# ERRATA

Document Being Updated: 5–6 K Interface Board EVM – (SLAU104)

This Errata (SLAZ006) ships with the 5–6 K Interface Board EVM Hardware Kit.

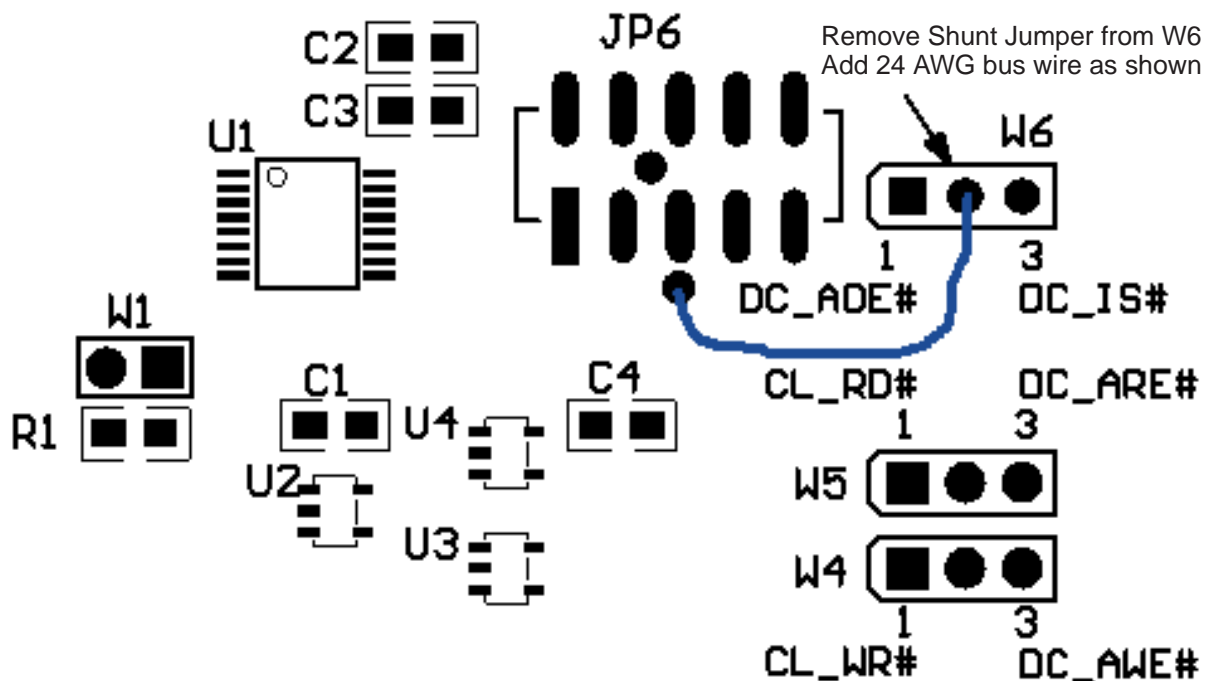
A recent discovery on the 5–6K interface board may prevent parallel EVMs mounted to the interface board from being written to when used in association with C6000 series DSKs. The DC\_AOE# signal at pins 1–2 of W6 only becomes active during read operations. It does not allow the address bits to toggle through U1 during write operations.

If this functionality is critical to the operation of the parallel EVM mounted on the interface board, please completely remove the shunt jumper at W6 and tie pin 2 (the center pin) to digital ground at JP6 pin 5.
